DART SERVICE INSTRUCTION

TO AMEND INSTALLATION INSTRUCTIONS D350-567 REV. E
AND INSTRUCTIONS FOR CONTINUED AIRWORTHINESS ICA-D350-567 REV. 2

REF. TCCA STC: SH92-18

A	NEW ISSUE (SEE PAR 16-510)	AJS	16.04.06
REV.	DESCRIPTION	BY	DATE
DESIGN	AJS	DART AEROSPACE LTD HAWKESBURY, ONTARIO, CANADA	
DRAWN	AJS		
CHECKED		DRAWING NO.	REV. A
MFG. APPR.	N/A	DSI 9745	SHEET 1 OF 3
APPROVED		TITLE	SCALE
DE APPR.		ALTERNATE FIRE EX LOCATION	NTS
DATE	16.04.06	COPYRIGHT © 2016 BY DART AEROSPACE LTD THIS DOCUMENT IS PRIVATE AND CONFIDENTIAL AND IS SUPPLIED ON THE EXPRESS CONDITION THAT IT IS NOT TO BE USED FOR ANY PURPOSE OR COPIED OR COMMUNICATED TO ANY OTHER PERSON WITHOUT WRITTEN PERMISSION FROM DART AEROSPACE LTD.

FIGURE 1

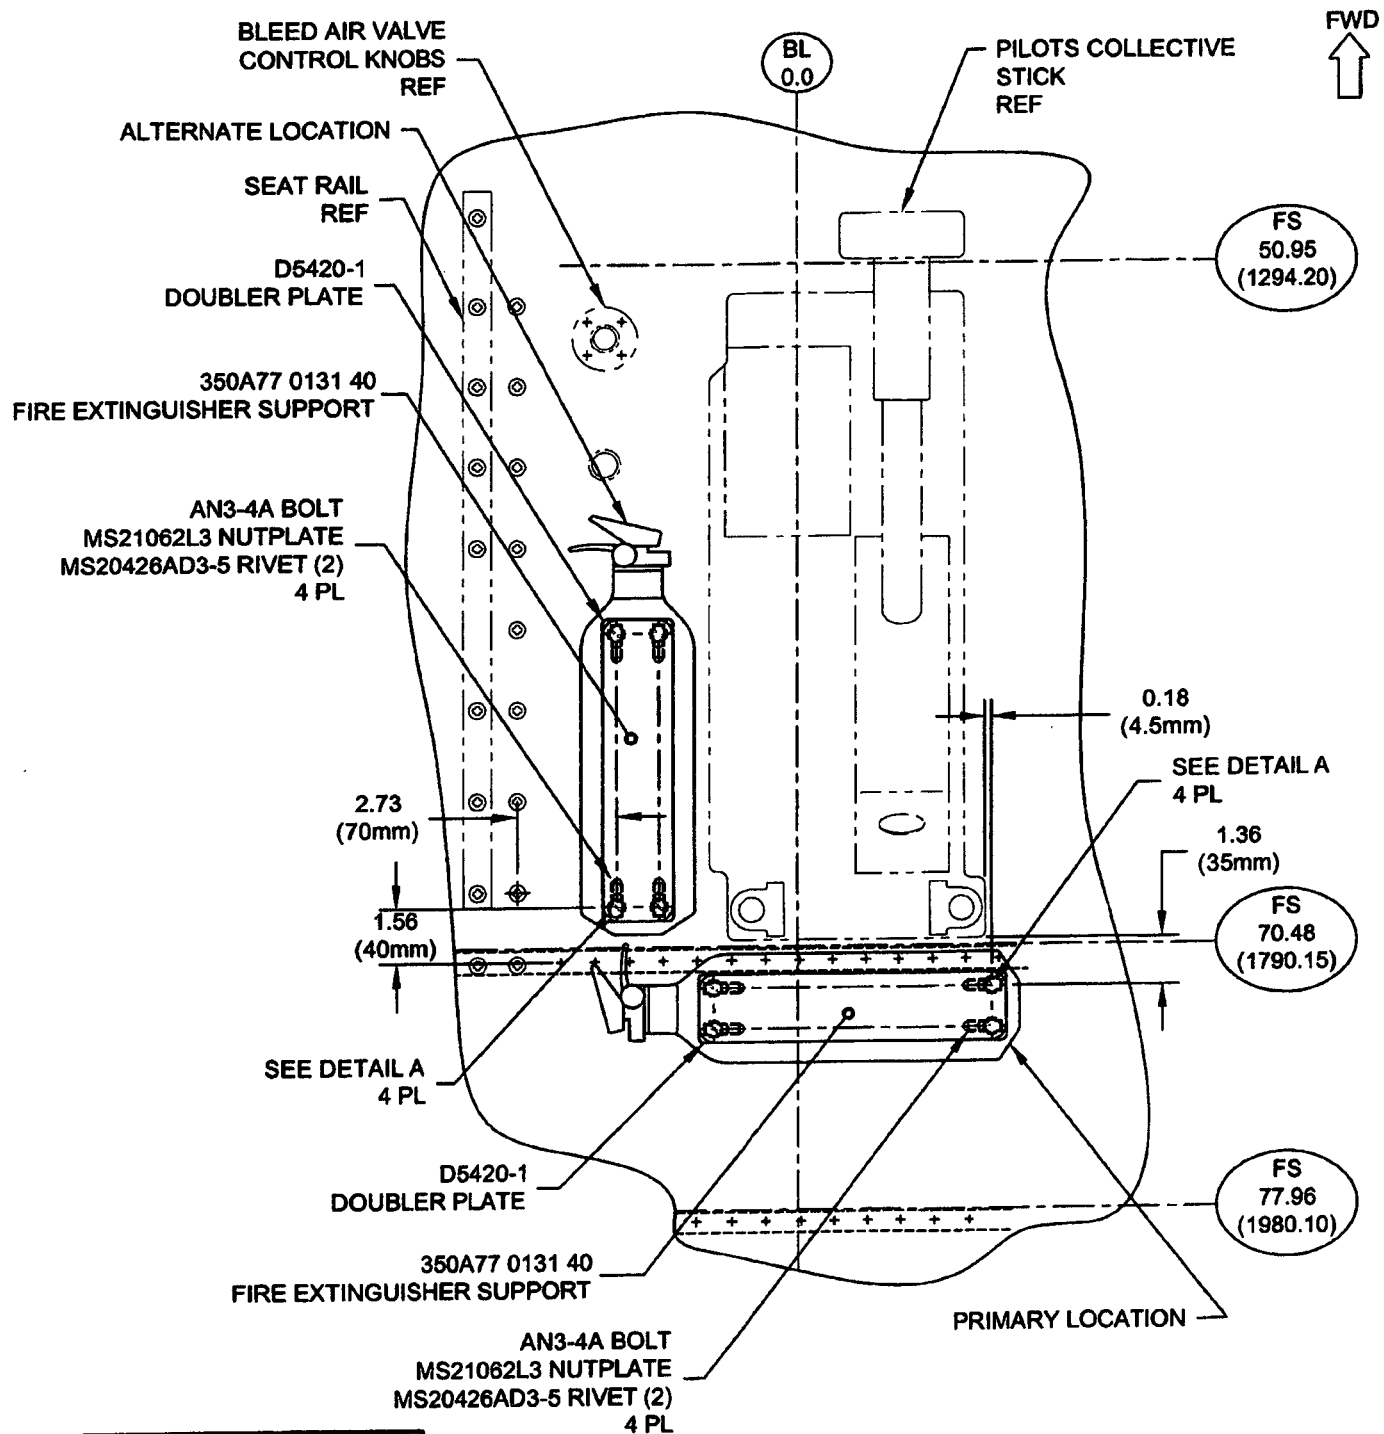
Remove and retain the cabin fire extinguisher P/N 1708337 B4 and Fire Extinguisher Support P/N 350A77 0131 40 from existing location. Per Figure 1, select the desired location for the fire extinguisher at either the "Primary" location or "Alternate" location.

Locate the D5420-1 Doubler Plate at the selected location per Figure 1 and transfer mark the holes from the D5420-1 Doubler Plate to the aircraft floor. Drill the nutplate hole pattern shown in Detail A. Touch up the drilled floor surface finish with chemical film (Alodine 1200/1201) per MIL-C-5541 and one coat of MIL-P-85582 or MIL-P-23377 primer.

Locate the D5420-1 Doubler Plate under the floor and install using qty (4) MS21062L3 nutplates and qty (8) MS20426AD3-5 Rivets (rivets fasten through floor and doubler). Locate the Fire Extinguisher Support P/N 350A77 0131 40 over the drilled holes and fasten it to the qty (4) MS21062L3 nutplates using qty (4) AN3-3A Bolts. Torque bolts 20-25 in-lbs (2.3-2.8 N-m). Reinstall the P/N 1708337 Fire Extinguisher per the Aircraft Maintenance Manual.
